## **HEARING REPORT** **VOLUME 1**

### **8 NOTICES OF REQUIREMENT FOR THE WARKWORTH PROJECT**

### **TE TUPU NGĀTAHI SUPPORTING GROWTH (AUCKLAND TRANSPORT & WAKA KOTAHI NZ TRANSPORT AGENCY)**

**EIGHT NOTIFIED NOTICES OF REQUIREMENT TO THE AUCKLAND COUNCIL UNITARY PLAN BY AUCKLAND TRANSPORT**

Figure 1 - Extract from NoR 4 Drawing showing tie into Matakana Link Road Roundabout

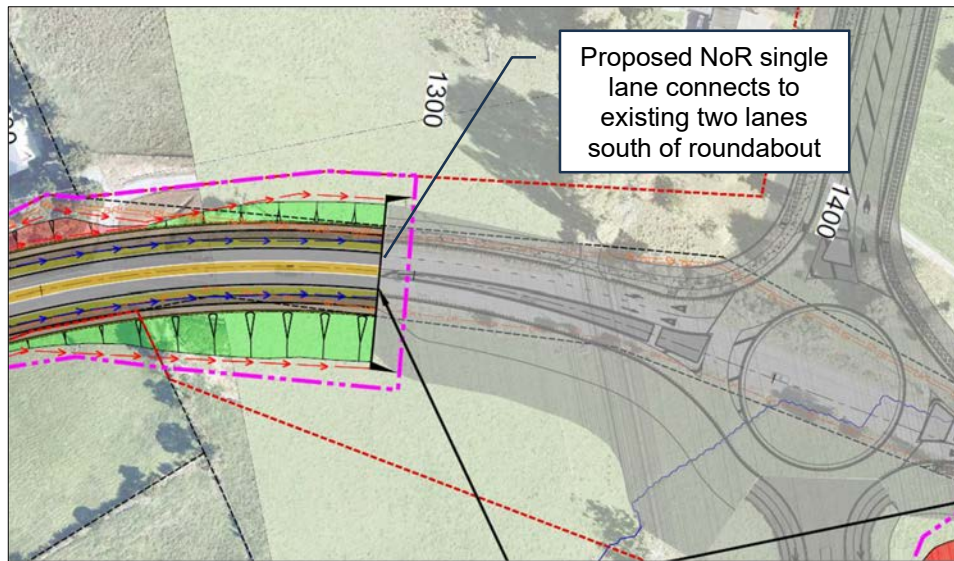
with the existing lanes at the roundabout as highlighted in Figure 1. This may affect the width of designation required. This is discussed in paragraphs 4.47 and 4.48.

Figure 2 - Road alignment for Warkworth North Precinct (left) and NoR (right)

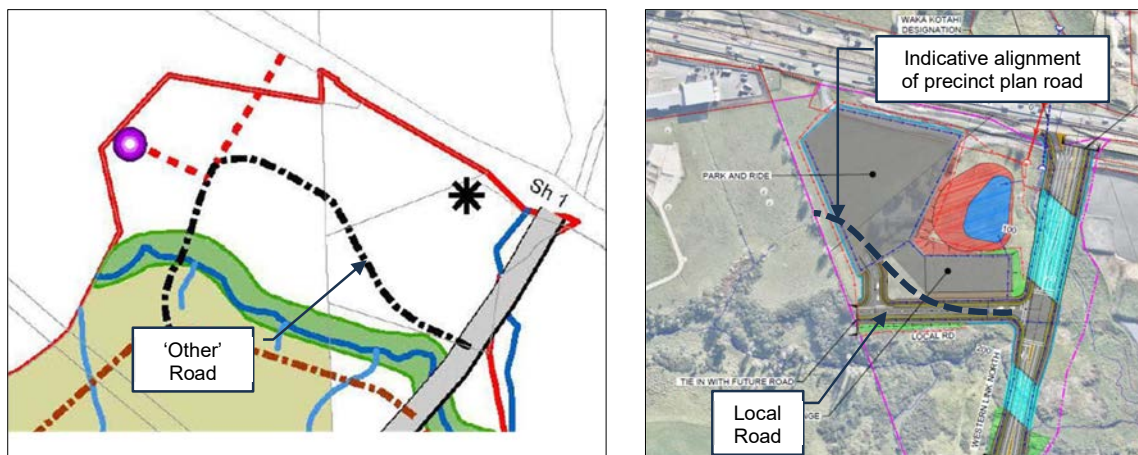
- 4.25 The alignment of the proposed local road south of the Public Transport Hub differs to the alignment shown on the Warkworth North Precinct Plan 2. This is illustrated in Figure 2.

- 4.26 As can be seen in the figure, the precinct plan shows the 'other' road having an alignment that curves to the north, whereas the NoR proposes a straight alignment up to the boundary of the NoR where it would then tie in with a future road. Where the transport infrastructure is not consistent with the Warkworth North Precinct Plan 2, such activities are Discretionary Activities<sup>3</sup>.
- 4.27 Whilst the 'other' roads on the precinct plan are shown indicatively, deviation from the plan would require assessment. For instance, the NoR proposed alignment shows that the road would be extend into an area with trees and a stream, whereas this is avoided on the precinct plan. Therefore, it would be necessary for the NoR to be assessed as a Discretionary Activity due to its non-compliance with the precinct plan.

*Figure 3 - Tie in between indicative NoR design and existing Matakana Link Road roundabout*

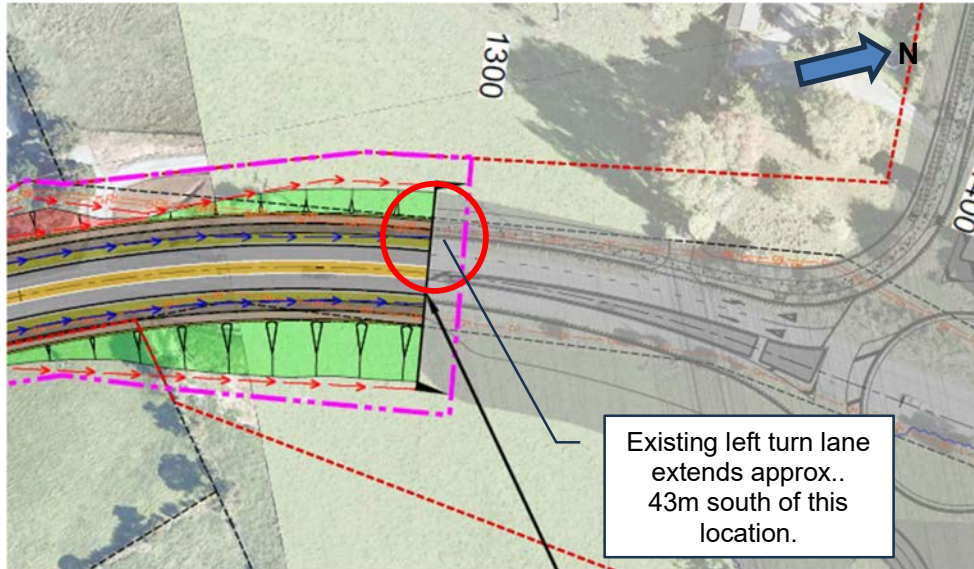
- 4.47 The indicative NoR design of the northbound lane for the Matakana Road Upgrade does not tie in correctly to the southern approach to the Matakana Link Road roundabout as highlighted by the red circle in Figure 3. The existing layout of Matakana Road flares from a single lane approach to two lanes, with the additional lane extending approximately 43m further south of the nose of the median island shown in the figure.

- 4.48 The proposed alignment should flare out to tie in with the two existing lanes. This would require the western side of the upgraded road to be moved further west. Whilst the designation is shown to be wider than the area required for the batter at this location, the applicant should demonstrate in evidence or at the hearing that if the proposed alignment does need to be adjusted, that this can be accommodated within the proposed designation boundary.

Figure 5 - Extract from NoR drawing SGA-DRG-WKW-300-GE-5000 C

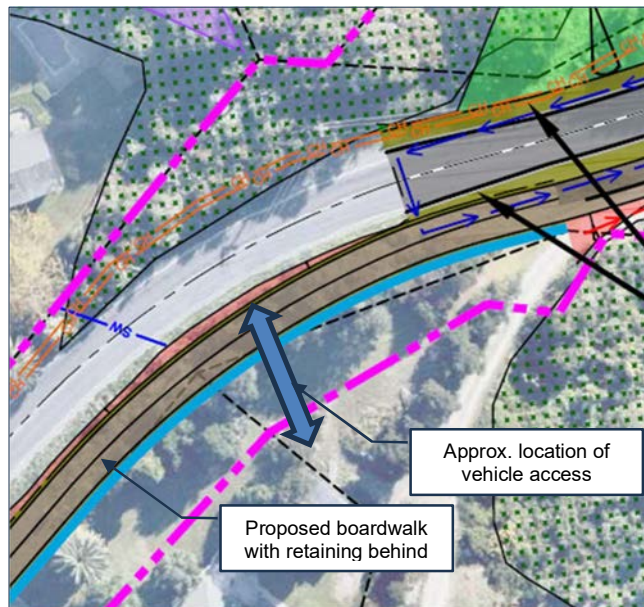
- 4.50 The NoR at the location of the new road proposes a boardwalk on the western side of the Sandspit Road with a retaining structure immediately behind it due to the embankment. This is illustrated in Figure 5.

- 4.51 The proposed road widening to create the new road intersection will result in the boardwalk being moved westwards. Whilst the NoR drawing shows a buffer between the proposed retaining wall and the designation boundary it is not clear how the NoR would affect the approved resource consent design and the visibility along Sandspit Road. The access is on the inside of the horizontal curve and the height of the land either side of the access could adversely affect visibility and thus the safe operation of the vehicle access.

Figure 7: Illustrates the addition of cut and fill batters and the extent of removing development from the pavement areas.

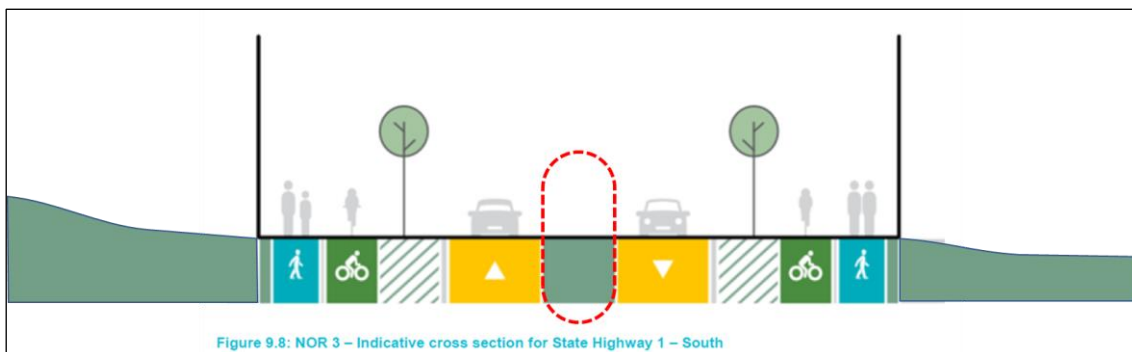
The difficulty with the significant berm widths, to accommodate batters, and level changes requiring retained edges over 350m in length on the eastern side opposite Fairwater Road is the fundamental lack of engaging edge activity and will result in a relatively isolated pedestrian experience, albeit landscape planting could provide some amenity. I have experienced some boring walks along other arterials with wide berms, such as East Coast Road, and Oteha Valley Road with the only reason to walk is for exercise or a forced march having no alternative – always take a friend. For cyclists it is slightly better as the time between points of interest becomes more bearable and the destination is reached more quickly.

For the reasons outlined above the inclusion within Condition 9 of the following would suffice as it would pick up on the key outcomes identified in the UDE and plan sheet 1/1 for NOR 3 State Highway 1 – South.

Figure 11: Illustrates the proposed local centre zone, master plans conceptual layout and the proposed designation.

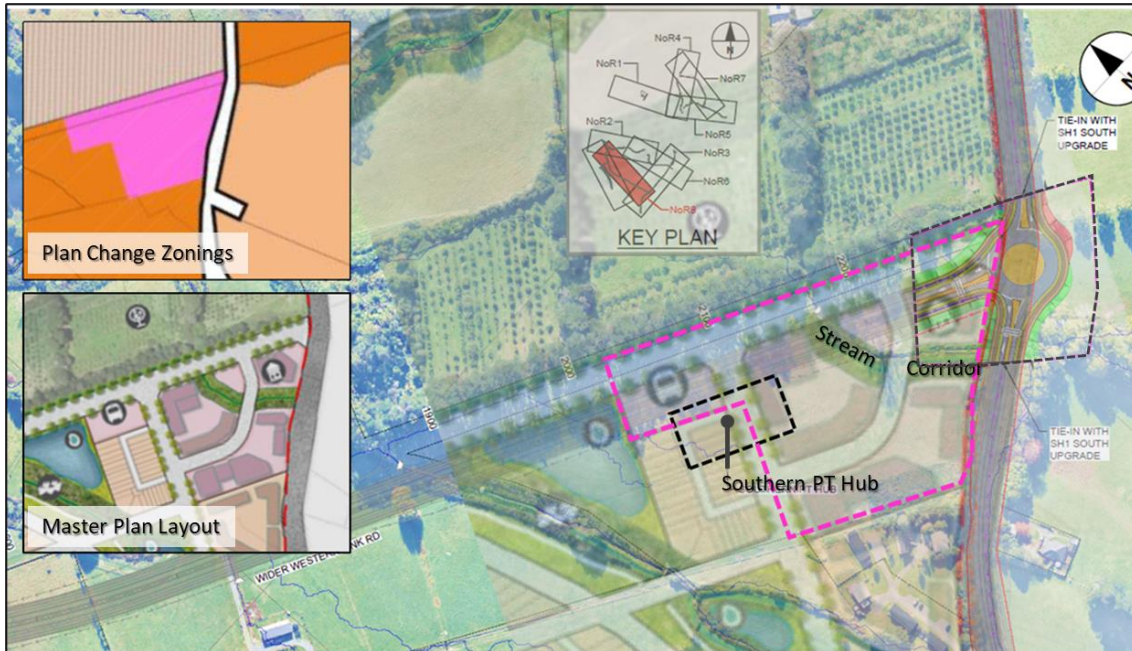
- Further reconsideration of the centre zones size and shape can be considered within the plan change process.
- Testing of any future disposal of land should be co-ordinated to ensure that a viable site and development solution can be enabled for the centre.

This aspect needs to be resolved early, that piecemeal development of the centre is avoided, and it presents itself to the corner and the WWL Road that supports the centre's legibility supports activity and enables the development of a well-functioning of a commercial centre. For these reasons I am not able to support this NoR from an urban design perspective at this stage.
